From: [Austin Griesbach](#)
To: [Transportation Commission](#)
Subject: CGS Says "Will", not Just "Should"
Date: Sunday, May 10, 2026 2:13:29 PM
Attachments: [2026-05-10_Madison_Vision_Zero_Progress.png](#)

I would like to comment on Agenda Item #4 regarding Regent Street for the 5/13 Transportation Commission meeting.

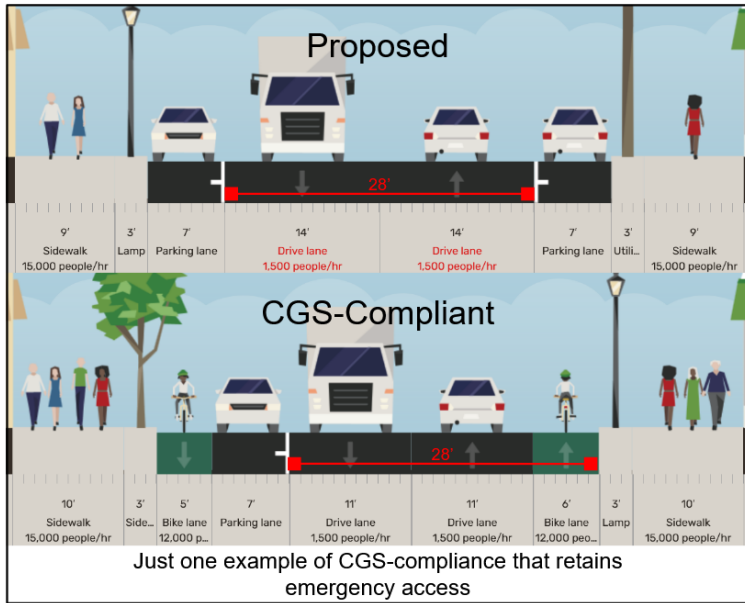
I strongly urge the Commission to ask staff to develop and present a one-side parking option for consideration, for the span of Regent Street within the scope of this project. If nothing else, it will allow the record to show that all the options were considered rather than casually dismissed out of hand. Such an option would allow a road profile like the one attached, with:

- 11-foot lanes that comply with CGS and national best practices described by NACTO
- A buffered bike lane on one side, providing the 28' emergency vehicle clearance
- A parking protected bike lane on the other side (with room for buffering)
- More room for sidewalks than the current design, and shorter crossings with less exposure to cars
